UNITED STATES PATENT AND TRADEMARK OFFICE

| APPLICATION NO. | FILING DATE | FIRST NAMED INVENTOR | ATTORNEY DOCKET NO. | CONFIRMATION NO. |
|--|-------------|-----------------------|---------------------|------------------|
| 10/671,842 | 09/25/2003 | Michael D. Brookshire | 121236.00003 | 9648 |

Office Action Summary

DETAILED ACTION

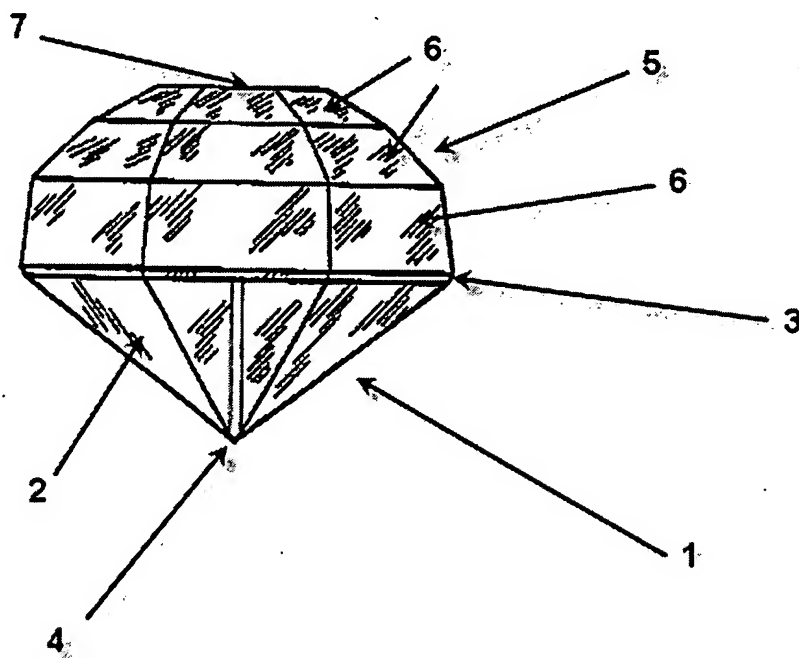
As for Claim 40, Stafford discloses of a cut gemstone (see figure below), comprising:
a pavilion (1) having a plurality of facets (2) disposed from a girdle (3) to a culet (4); and
a dome-shaped crown (5) disposed above the girdle (3), wherein the girdle (3) extends no further than a widest circumference (bottom of 5) of the dome-shaped crown (5) and the pavilion (1) extends no further than a widest circumference of the girdle (3), the dome-shaped crown (5) formed from a plurality of sets of facets (6) cut with monotonically decreasing angles to form a curved contour in accordance with a dome shape from the girdle (3) to an apex (7) of the dome-shaped crown (5), each facet (6) within the sets of facets (6) being polygonal in shape with opposing corners of the polygon nested between adjacent facets (6).

As for Claim 47, Stafford discloses of a cut gemstone (see figure below), comprising:

a dome-shaped crown (5) disposed above the girdle (3), wherein the girdle (3) extends no further than a widest circumference (bottom of 5) of the dome-shaped crown (5) and the pavilion (1) extends no further than a widest circumference of the girdle (3), the dome-shaped crown (5) formed from a plurality of sets of facets (6) cut with monotonically decreasing angles to form a curved contour in accordance with a dome shape from the girdle (3) to an apex (7) of the dome-shaped crown (5).

Re: Claim 48, wherein each facet (6) within the sets of facets (6) is polygonal in shape with opposing corners of the polygon nested between adjacent facets (6).

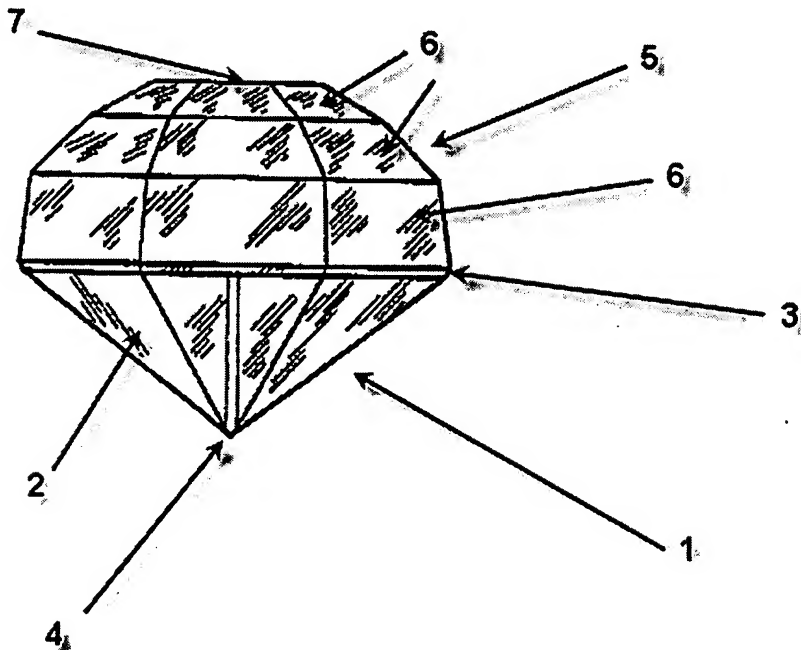
As for Claim 1, Stafford teaches of a diamond (see figure below), comprising:

a pavilion (1) having a plurality of facets (6) disposed from a girdle (3) to a culet (4), each of the plurality of facets (6) having a continuous flat surface extending from the girdle (3) to the culet (4), wherein an edge of a first adjoining facet contacts an edge of a second adjoining facet along a common radial boundary; and

a dome-shaped crown (5) disposed above the girdle (3), wherein the girdle (3) extends no further than a widest circumference (bottom of 5) of the dome-shaped crown (5) and the pavilion (1) extends no further than a widest circumference of the girdle (3), the dome-shaped crown (5) formed from sets of facets cut with monotonically decreasing angles to form a curved contour in accordance with a dome shape from the girdle (3) to an apex (7) of the dome-shaped crown (5), each facet (6) within the sets of facets (6) nested between adjacent facets (6), each of the sets of facets (6) having monotonically decreasing surface area from the girdle (3) to the apex (7) of the dome-shaped crown (5).

The difference between the claim and Stafford is that Stafford does not expressly disclose that the dome-shaped crown (5) is formed from at least five sets of facets; that each facet (6) within the set of facets (6) being hexagonal in shape; and that the apex (7) of the dome-shaped crown (5) has less surface area than each facet (6) from the sets of facets (6). It would have been an obvious matter of design choice to modify Stafford (adding additional sets of facets between the girdle and apex of the crown so as to go from 3 sets to at least 5 sets of facets), since applicant has not disclosed that such a particular orientation creates any unexpected result. It appears that the invention would perform equally well as the invention disclosed by Stafford. It is extremely old, well known, readily apparent and profoundly obvious to change the size, shape, number, orientation, angles, percentages, and create ranges for facets and the gemstone in its entirety as to merely alter the aesthetics of said gemstone for the corresponding and resulting properties including brilliance, radiance, etc. for the utility of mere user preference. It is also extremely well known that altering said features will produce different properties radiating from said gemstone, depending on the changes and alterations made. Therein, once again, lies the pertinence behind such, as no unexpected result, viewed by one skilled in the art; will occur, with any of the above possible changes or alterations to any given gemstone.
